**ADDENDUM NO. 1  
TO THE  
SPECIFICATIONS AND CONTRACT DOCUMENTS**

**City Project No. STR25002C**

**2025 CITYWIDE PAVEMENT REPAIRS PHASE 2**

June 11, 2025

2025 CITYWIDE PAVEMENT REPAIRS QUANTITY SUMMARY

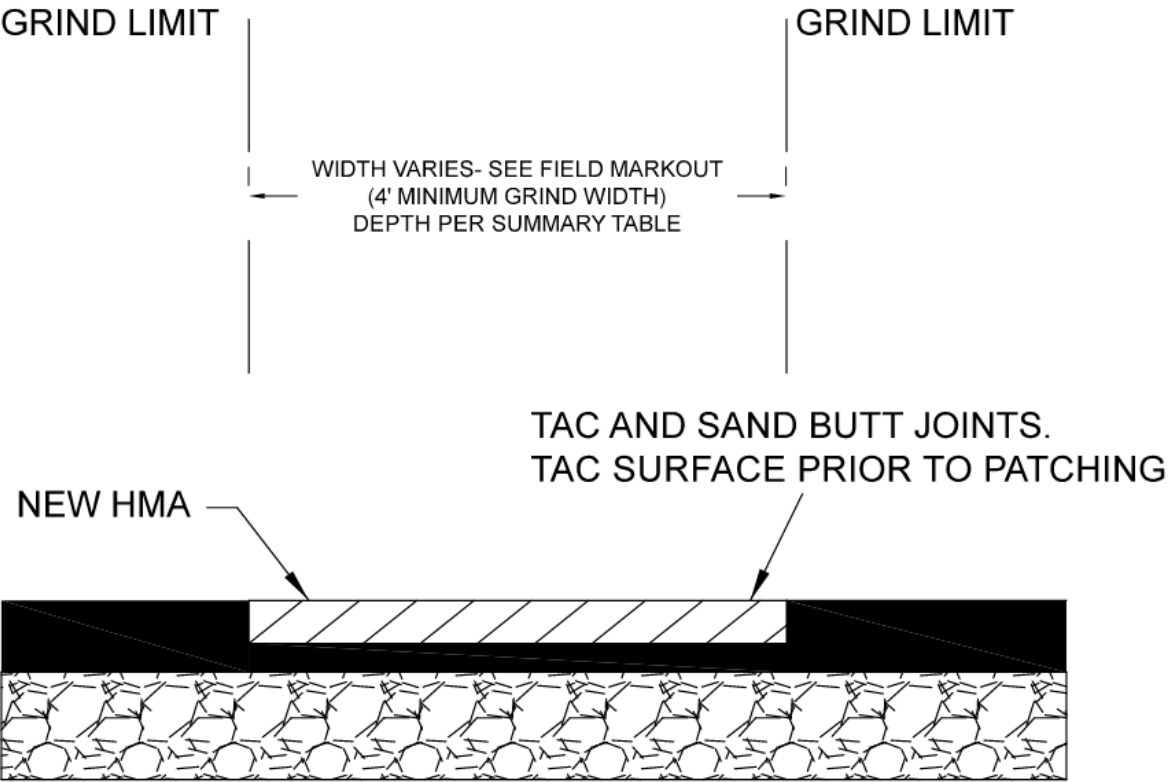
DELETE Quantity Summary plan sheet and INSERT revised Quantity Summary plan sheet attached to this addendum

REVISED 6-11-25 Addendum 1

CONSTRUCTION NOTES (REVISED 6/11/2025 ADDENDUM 1):

1. GRIND AND INLAY LIMITS PAINTED IN FIELD. SEE ABOVE QUANTITY SCHEDULE FOR TOTAL TREATMENT AREA AND PAVEMENT/MILLING DEPTHS
2. MANHOLE AND VALVE CANS TOP BE ADJUSTED WITHIN INLAY LIMITS. MANHOLES AND VALVBES CANS MARKED IN FIELD IF OUTSIDE OF INLAY LIMIT.
- 3.TRAFFIC CONTROL: PROVIDE ONE LANE OPEN DURING WORK HOURS AT ALL TIME (ONE WAY FLAGGING). ROAD TO BE OPEN TO FREE FLOR TRAFFIC NON-WORK HOURS. TRAFFIC CONTROL PLAN TO BE SUBMITTED FOR APPROVAL.
4. ALL HMA TO BE WSDOT CL 1/2" PG 64-22 WITH MAX OF 20% RAP. COMPACTION PER WSDOT STANDARD SPECIFICATIONS
5. TAC TO BE PLACED ON EXISTING HMA AND CONCRETE SURGFACES PRIOR TO PAVING. ALL BUTT JOINTS TO BE TAC AND SANDED AT SURRFACE UPON COMPLETION.
6. PRESERVE PAVEMENT MARKINGS UNLESS DIRECTED OTHERWISE BY ENGINEER. CONTRACTOR TO PROVIDE TEMPORARY MARKINSG IF DAMAGED DURING CONSTRUCTION.
